## REVISED RESPONSE TO REQUEST FOR ADDITIONAL INFORMATION

### APR1400 Design Certification

Docket No. 52-046

RAI No.: 470-8552  
SRP Section: 16 – Technical Specifications  
Application Section: 16.3.3.1  
Date of RAI Issue: 04/26/2016

Figure 7.2-11

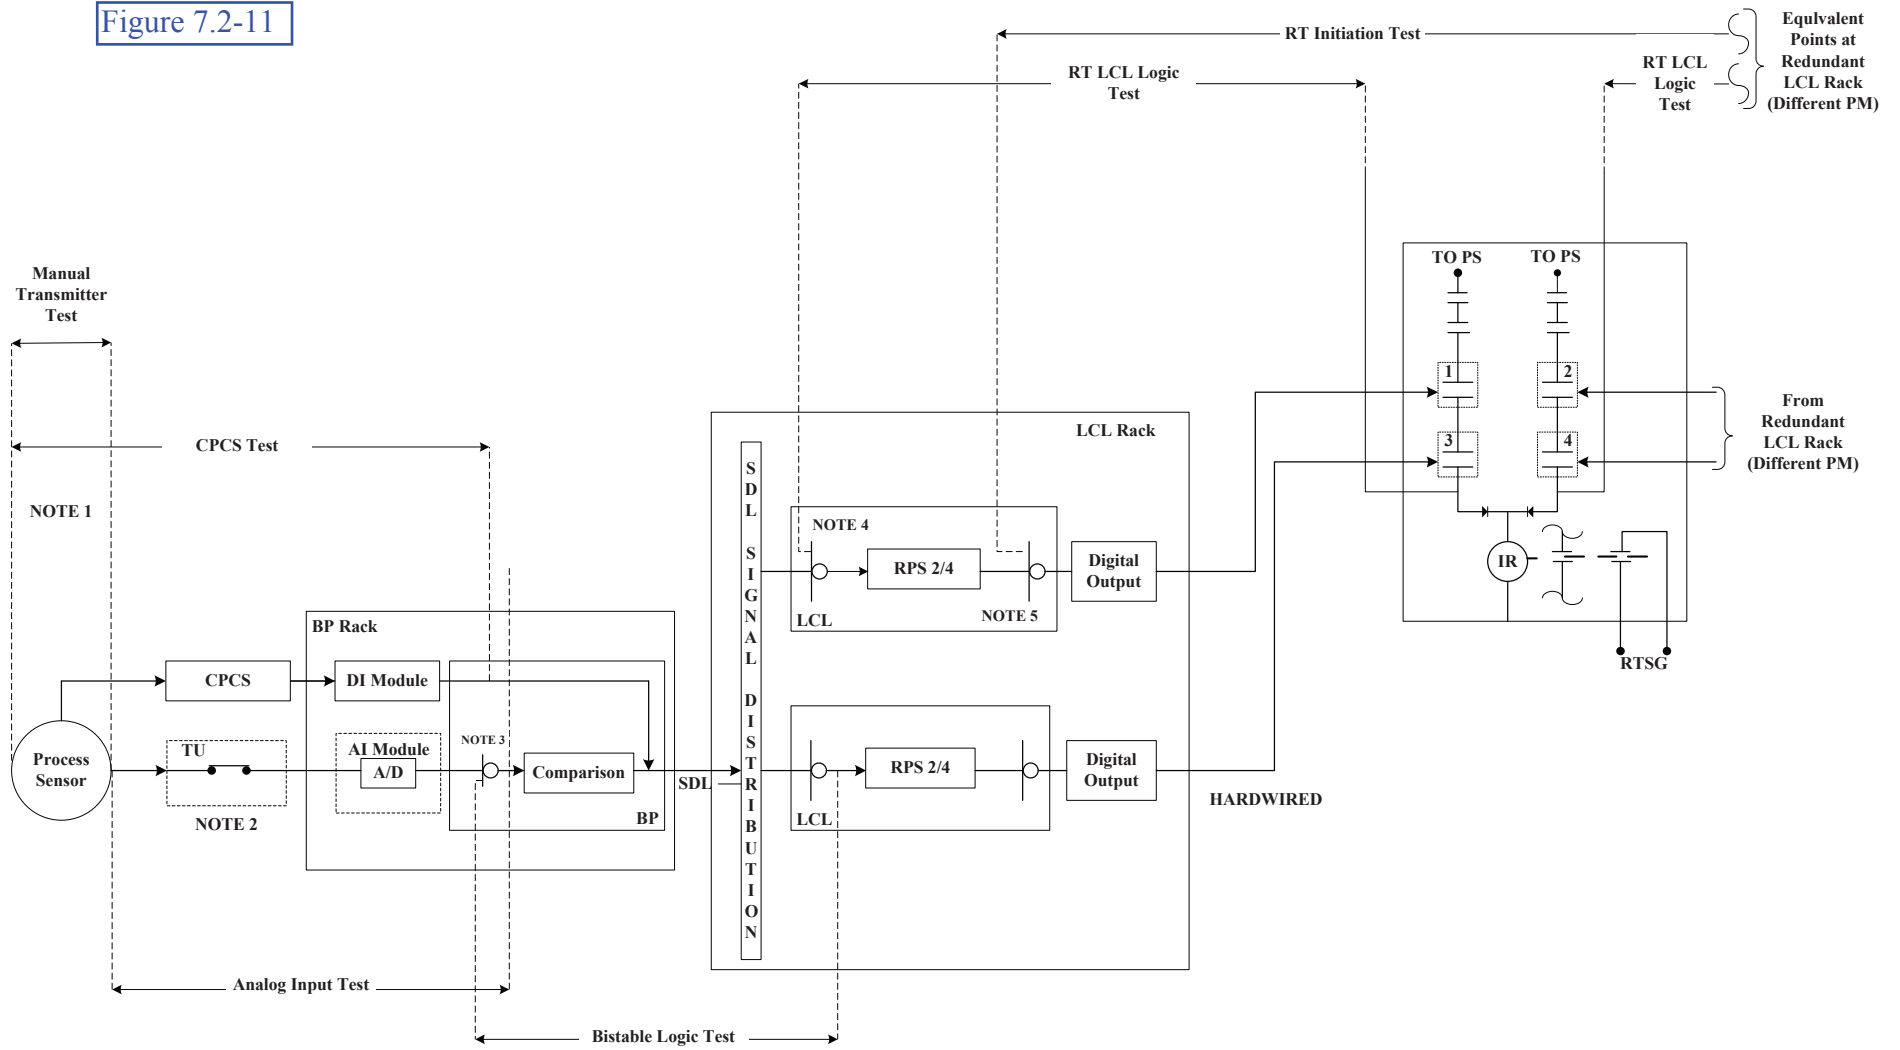
2. Notice that DCD Figure 7.2-11 does not depict "CPCS Test" and "Manual Trip Test", which are described in DCD Section 7.2.2.5. The applicant is requested to revise DCD Tier 2 Section 7.2 so that Section 7.2.2.5 and Figure 7.2-11 are correctly aligned. In addition, consider adding a discussion in DCD Tier 2 Section 7.3 that describes the testing for the ESFAS instrumentation loops with the same level of detail as the requested revised description in DCD Tier 2 Section 7.2.2.5, and also a figure equivalent to Figure 7.2-11. Notice that Figure 7.2-11 depicts no tests for ESFAS related components after the input to the actuation logic in the group controller.

4. The applicant is requested to explain what meaning the "OR" logical gate symbols on Figure 7.2-11 are intended to convey; especially with respect to depicting testing overlap. The requested information is needed to enable the NRC staff to determine whether or not surveillances for RPS and ESFAS instrumentation functions satisfy 10 CFR 50.36 requirements.

1. Table 1 is prepared based on DCD Tier 2 Figure 7.2-11, which shows the testing overlap for the periodic manual tests required to verify the integrity of the RPS functions during power operation of the plant. The component names and descriptions in the figure are identified by relationship with the testing type provided in DCD Tier 2 Section 7.2.2.5, "System Testing and Inoperable Surveillance". Additionally, the "CPCS" and "CPCS test" will be included in DCD Tier 2 Figure 7.2-11.

2. The missing information of CPCS and CPCS Test in DCD Tier 2 Figure 7.2-11 will be added.

The logical OR symbols on Figures 7.2-11 and 7.3-24 will be explained in DCD Tier 2, In Figure 7.2-11, the logical OR in the receiving stage of bistable processor (BP) indicates that BP logic is processed either by the actual signal or by the test signal. The logical OR in the receiving stage of LCL indicates that local coincidence logic (LCL) logic is processed either by the actual signal or by the test signal. The logical OR in the transmitting stage of LCL or the receiving stage of the digital output module indicates that the digital output module generates the output either by the actual signal or by the test signal.

DCD Tier 2 Figure 7.2-11 will be revised as indicated in the attachment associated with this response.
